TECHNICAL BULLETIN		
	October 2008 TB 2511

Revised Intake Manifold Mounting Hardware For
2000-2008 Mack MP7 & MP8 Diesel Engines

Figure 1. Intake Manifold Mounting Hardware

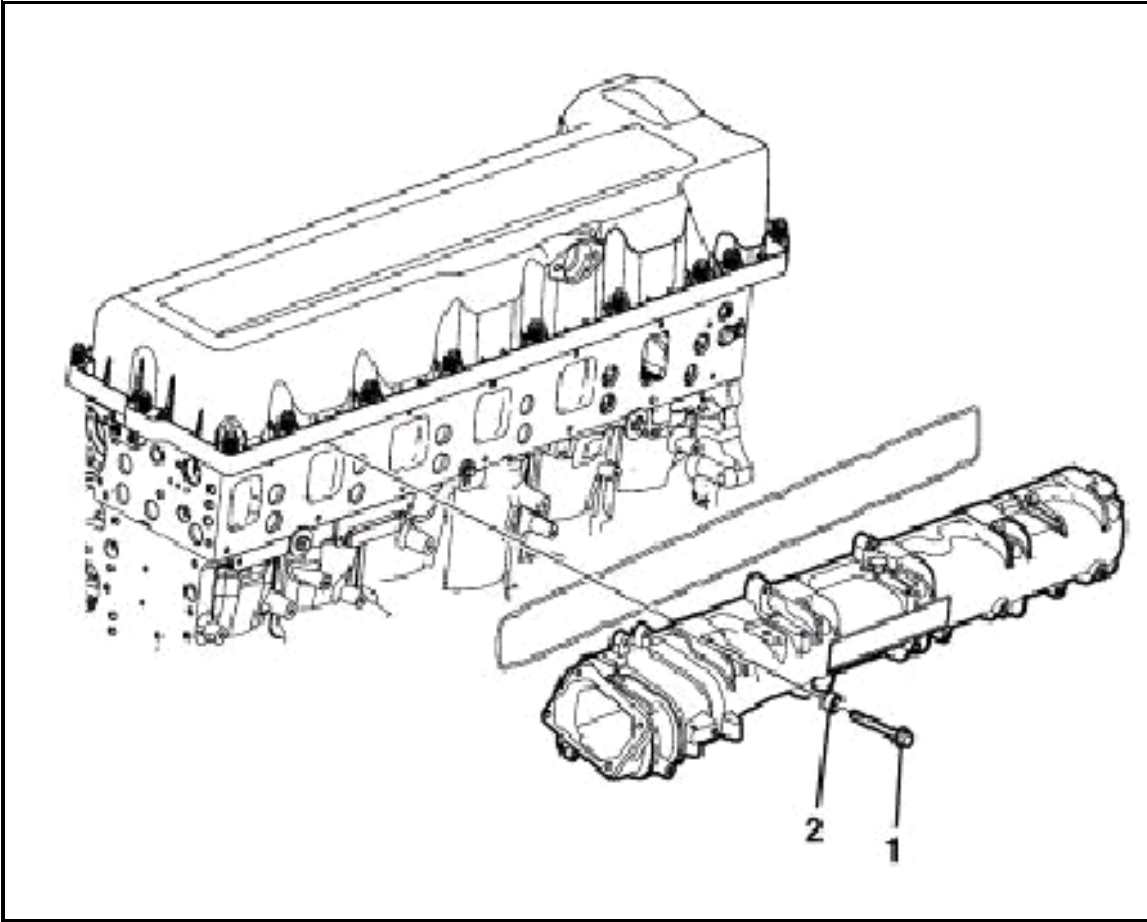
During September of 2008 the replacement intake manifold mounting hardware for Mack MP7 and MP8 engines has been developed and improved from the original hardware. These components are available through Mack Parts Systems. The new hardware consists of 12 flange screws, Part #20976035, and spacers Part #948871.

Should loose or missing intake manifold mounting screws be encountered, or anytime the intake manifold has been removed, the new flange screws and spacers must be used to replace all the existing manifold mounting hardware.

Key	Quantity	Part Number	Description
1	12	20976035	Flange screw, intake manifold mounting
2	1	2948871	Spacer, intake manifold mounting
